REMARKS

This paper is submitted responsive to the official action of August 23, 2002. Reconsideration of the application in light of the accompanying remarks and amendments is respectfully requested.

Front End Loader

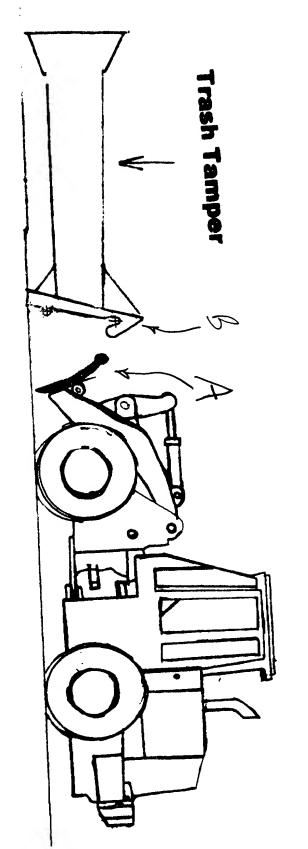
In the aforesaid action, the Examiner objected to the drawings, indicating that a figure should be submitted showing a front end loader. A figure has been enclosed herewith for the Examiner's review, and shows a packing attachment or "trash tamper", in accordance with the present invention positioned relative to a front end loader. In this figure, the front end loader has a mounting assembly A which engages with the mounting structure B of the apparatus of the present invention so that the packing apparatus can be used for compacting trash, for example within the open hopper of a truck. As set forth in the specification, the advantageous structure of the packing attachment of the present invention allows for use of the packing attachment to compact trash at a substantially vertical angle, which allows all trash within a hopper of a truck to be compacted, and which avoids the need for entering the hopper of the truck at an angle which can also damage the truck.

It is believed that the proposed figure enclosed herewith is not necessary for a proper understanding of the invention, and that the specification and drawings as filed thoroughly conveys the subject matter of the present invention. Nevertheless, if the Examiner believes that this additional figure improves the

clarity and understandability of the specification, applicant will submit a formal drawing and amend the specification to incorporate reference to this drawing upon approval of the proposed drawing correction by the Examiner.
